**Road Safety Audit
Stage 1
for
APARTMENT DEVELOPMENT
AT
SCHOLARSTOWN RD, RATHFARNHAM, DUBLIN 16**

Reference: RSM/MOB/170822/SCHOLARSTOWN-RSA1 OCT22

| Project Title | Access to apartment development, Scholarstown Rd, Dublin |
| Document Title | Stage 1 Road Safety Audit |

Figure 6: Proposed Raised Entry Treatment on Entry to Site

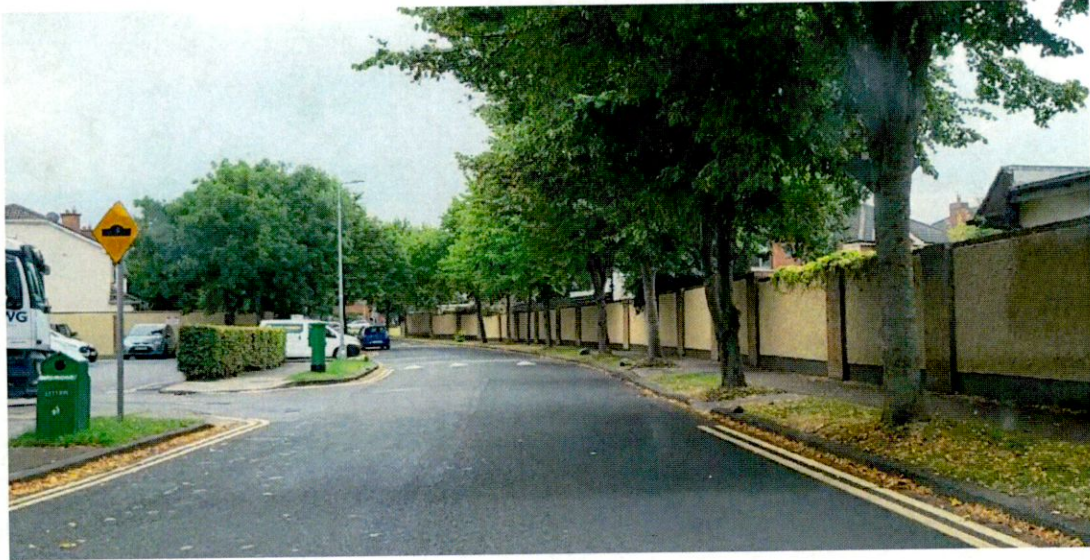
There is formal traffic calming provided on entry to the Orlagh Grove in the form of vertical deflection at a raised zebra crossing to the north of the proposed site access, which is shown in figure 3, and which appears to be effective in reducing vehicle speeds on entry to the link. The site is also posted with 30 km/hr slow zone speed limit signage on the nearside on entry to the residential area. Existing vertical deflection measures are also provided on the link further south of the proposed access point, as shown in figure 7. The design for the proposed development site also includes for vertical deflection in the form of a raised pedestrian crossing point across the mouth of the access junction, which should assist in maintaining low speeds on entry to the site. It was noted that sightlines illustrated on the design plan have been taken from a distance of 2.4m back from the channel line of the major road, which is the x-distance applicable for lightly trafficked junctions, however it was noted that vehicles egressing from the development site will be stopped at a significant offset from the channel line due to the proposals for a raised crossing at the junction mouth, which is intended to prioritise the movement of pedestrians. For the reduced visibility x-distance to be achievable, motorists will need to stop closer to the stop line, which will block the pedestrian crossing.

1. Visibility at the site access junction should be clear and unobstructed at all times in accordance with traffic speeds, with visibility splay requirements to be determined on the basis of prevalent 85th percentile speeds on the adjacent link, and adjusted where necessary to take into account the likely waiting position of vehicles at a significant offset from the channel line.
2. Low internal site speeds should also be encouraged, with provision for additional vertical or horizontal traffic calming measures where necessary on the internal access road to maintain low vehicle speeds.

Figure 8: Visibility to left from proposed Site Access showing existing high wall and street furniture

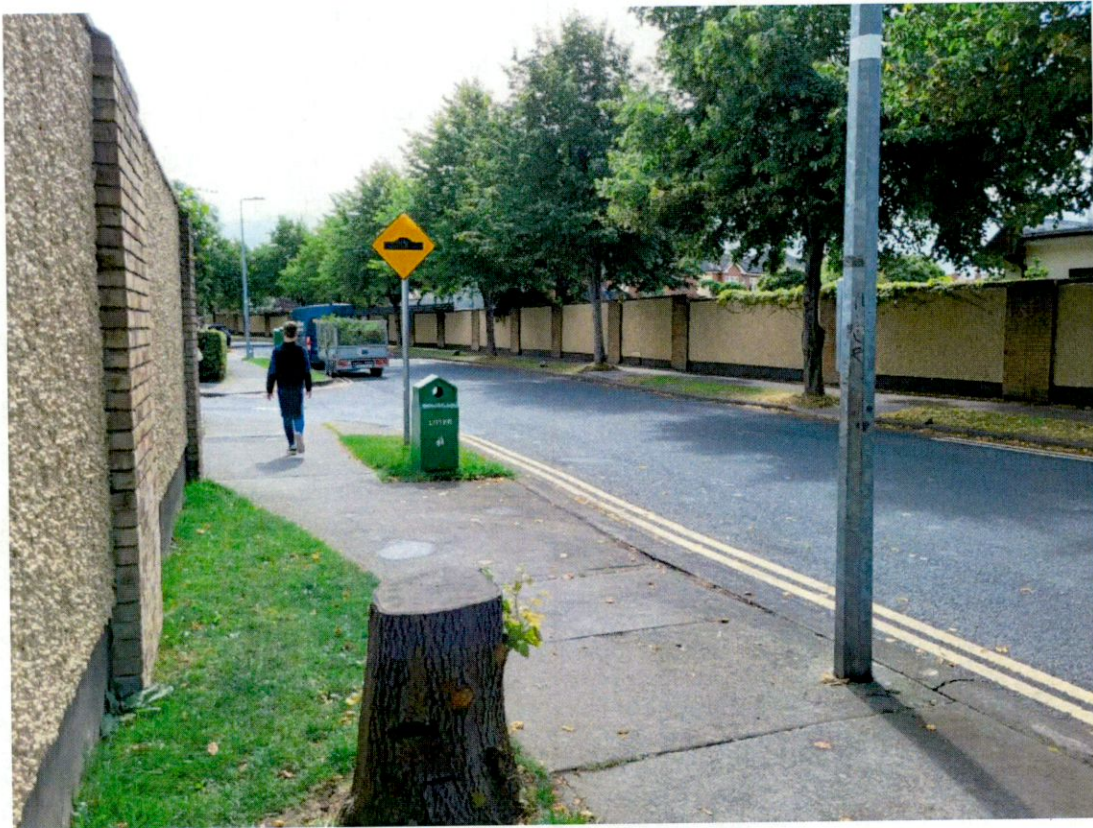
There were no details provided on proposed boundary treatment or landscaping for the site or for any of the internal areas of the site, and no provision for site clearance, with a significant number of mature trees noted within the site, with mature overhanging trees also located within the verges on both sides of Orlagh Avenue leading to fallen leaves and slippy conditions underneath and likely contributing to darker conditions and interference with street lighting during the hours of darkness. Within the site, inappropriately located boundaries or landscaping which exceeds 1.05m in height can reduce forward visibility and intervisibility between pedestrians and motorists, and may lead to an increased risk of conflict with oncoming vehicles and VRUs. Inappropriate boundary treatment or landscaping at or on approaches to the proposed site access can also present an obstruction in the visibility splay at a junction, leading to an increased risk of pulling

out type incidents and right-angled collisions. There are also a number of large utility cabinets located in close proximity to the proposed site access point, which can obstruct pedestrian movement and can also obstruct clear visibility to and from oncoming traffic.

1. Detailed design should include provision for site clearance to indicate treatment of all existing features on the site, with provision for reinstatement of all features displaced by the works where necessary, at a safe location which does not present a hazard to road users.
2. Landscaping [proposals to be clarified at detailed design stage, with all trees and landscaping to be located away from positions which could increase the risk of conflict or have a negative impact on intervisibility at Vulnerable Road User (VRU) desire lines.
3. Any potential intervisibility obstructions arising from boundary treatment, internal walls, landscaping, utilities, or street furniture should be removed or relocated or provided at a height less than 1.05m, and all trees, hedges and landscaping should be located away

from positions which could increase the risk of conflict for road users, including pedestrians, with pedestrians to be clearly visible from a point 2m back from each crossing and desire line or conflict point.

4. Trees, boundaries and landscaping should be offset a safe distance from the carriageway edges and ideally away from footways or areas where shedding leaves and tree roots may cause slip/trip hazards, or where street lighting luminescence may be compromised.
5. All features and street furniture including fencing, gate posts/pillars, sign faces, landscaping and lighting columns should be at a minimum recommended 450mm offset from the kerb in an urban environment. Solid continuous hazards such as walls should be a minimum 600mm offset from the kerb edges.

| To Be Completed By Designer | | | | To Be Completed by Audit Team Leader |
|--------------------------------------|---------------------------|---------------------------------------|--|---|
| 2.1.6 | Yes | Yes | These items will be addressed | |

Figure 11: sharp internal bend with nearside sightline restrictions for northeast bound vehicles

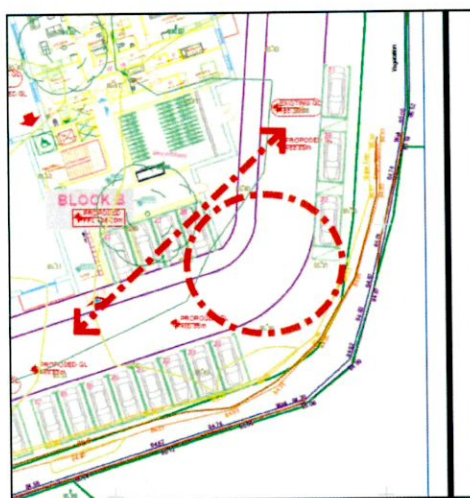
There was no swept path analysis provided to demonstrate that the proposed geometry of the site access and internal road will safely accommodate the swept paths and turning movements of all anticipated vehicle sizes. A relatively sharp internal curve was noted with no provision for widening on the bend. Low radii values are not advisable on single carriageway roads due to the potential for side swipe and head on collision risk with oncoming vehicles. The nearside boundary treatment and parked vehicles may also restrict sightlines on the inside of the bend at this location, as highlighted in figure 11.

1. The geometry of the site access and internal road should be subject to swept path analysis for the worst-case scenario anticipated vehicle sizes, as well as more frequent vehicle types, to demonstrate that the proposed layout will safely accommodate the swept paths and turning movements of all anticipated vehicle sizes with adequate margins of safety, and that two-way movement will be possible on the proposed layout without encroachment into the VRU zone.
2. All internal radii should safely accommodate two-way movement without presenting a head on or side swipe collision risk, and forward visibility around bends should not be compromised by boundary treatment, building lines or the location of parking bays.

| To Be Completed By Designer | | | | To Be Completed by Audit Team Leader |
|--------------------------------------|---------------------------|---------------------------------------|--|---|
| 2.2.1 | Yes | Yes | These items will be addressed. A vehicle tracking analysis has be undertaken. | |

Figure 13: Overlapping visibility plays at closely spaced access points

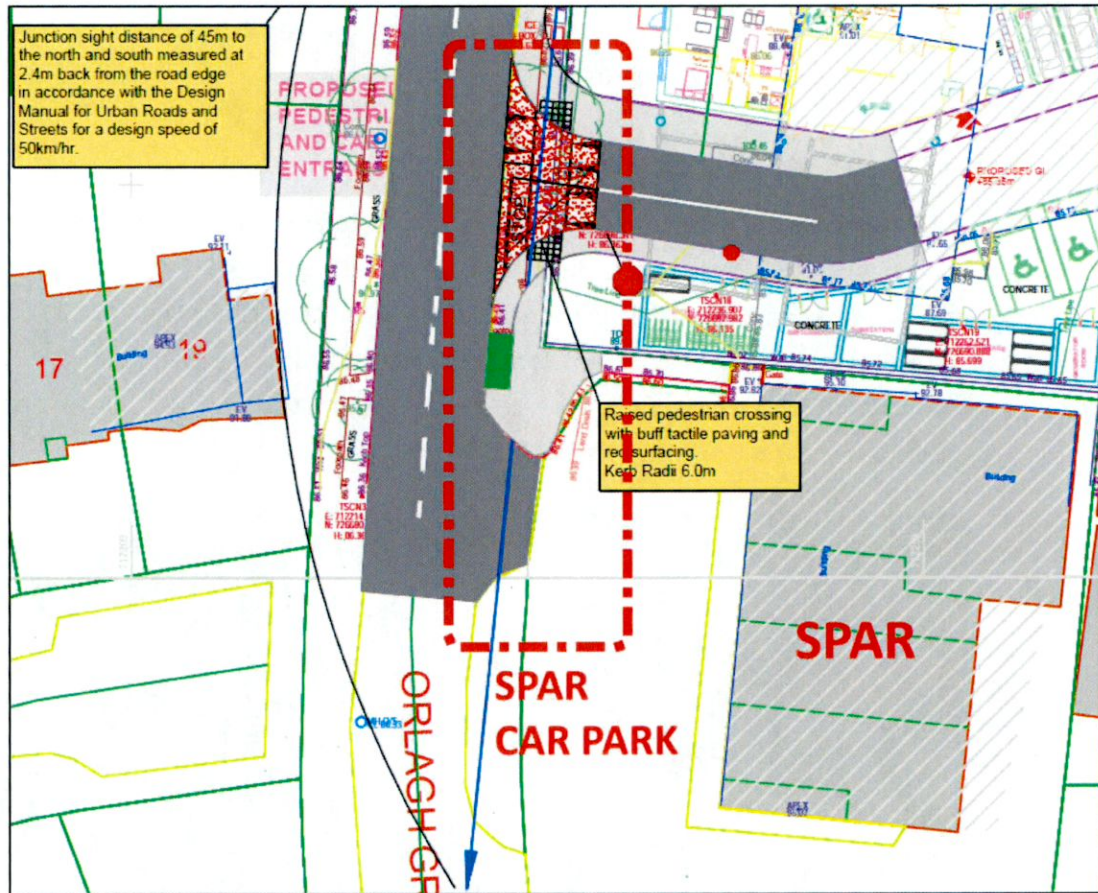
The proposed site access is located in very close proximity to the adjacent access to the Spar Supermarket and associated surface car park, and visibility splays will overlap, as highlighted in figure 13. The demand for use of this access point is unknown, however the Audit Team considered there is likely to be a relatively frequent level of usage at this location, as access and egress to and from food retail developments typically have high trip rates. Overlapping visibility splays represent a departure from standard on single carriageway roads, as vehicles waiting to pull out from either access point simultaneously will restrict visibility to and from oncoming vehicles, resulting in an increased risk of right-angled collisions and pulling out type incidents.

1. The proposed access should not impact on the safe operation of any other existing junctions or access points in close proximity. Closely spaced access points should be avoided, and ideally combined where feasible to form one access point and to limit the number and frequency of conflicting turning movements occurring in close proximity on the link.
2. Where access points cannot be combined and where visibility plays overlap, associated risks should be mitigated where feasible, with egress from the Spar car park to be permitted from the southernmost access point only, and with suitable low boundary treatment to be

provided between the two sites to ensure enhanced intervisibility can be achieved between the two overlapping access points.

| To Be Completed By Designer | | | | To Be Completed by Audit Team Leader |
|--------------------------------------|---------------------------|---------------------------------------|--|---|
| 2.2.2 | Yes | Yes | These items will be addressed | |

Figure 21: Missing Lighting Lamp on Column at site boundary

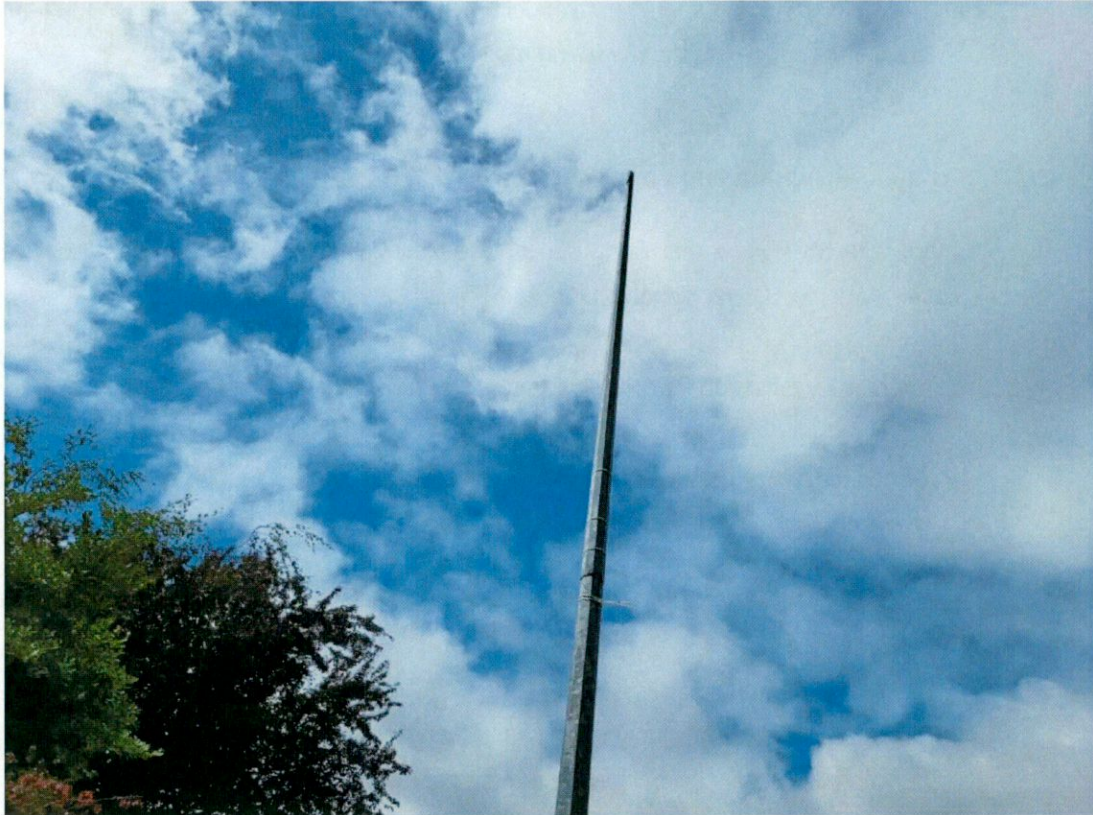
New lighting columns have been shown within the site, however they appear to be located in close proximity to the kerb edges where vehicles will be turning and reversing, presenting an increased risk that the columns may be struck. Column locations may also obstruct the movement of pedestrians and cyclists on the narrow internal footways. A full review of existing lighting provision was not possible at the time of the site visit, however it was noted that existing lighting on Scholarstown Rd adjacent to the site appears dated, and a lamp was also missing from one of the columns, as shown in figure 21. The dense tree foliage within verges on both

sides of Orlagh Grove are also likely to reduce the effectiveness of street lighting. Insufficient lighting within or surrounding the site may lead to an increased risk of road user conflict during the hours of darkness.

1. Existing Lighting Provision surrounding the site should be reviewed and enhanced where necessary to ensure the boundary of the site and all site approaches are well lit in the hours of darkness.
2. All new lighting columns should be provided at a sufficient offset from the carriageway edge to minimise the risk of being struck by passing and turning vehicles, with a minimum recommended 450mm to be provided in urban environments. Where columns cannot be moved, provision should be made for suitable protection to prevent vehicle strike.

3. Lighting columns should ideally be located to the rear of footways in a location which does not obstruct the movement of VRUs.
4. Internal site lighting should not interfere with lighting on the external public road network, and should not cause dazzle to passing motorists.

| 2.4.1 | Yes | Yes | These items will be addressed | |
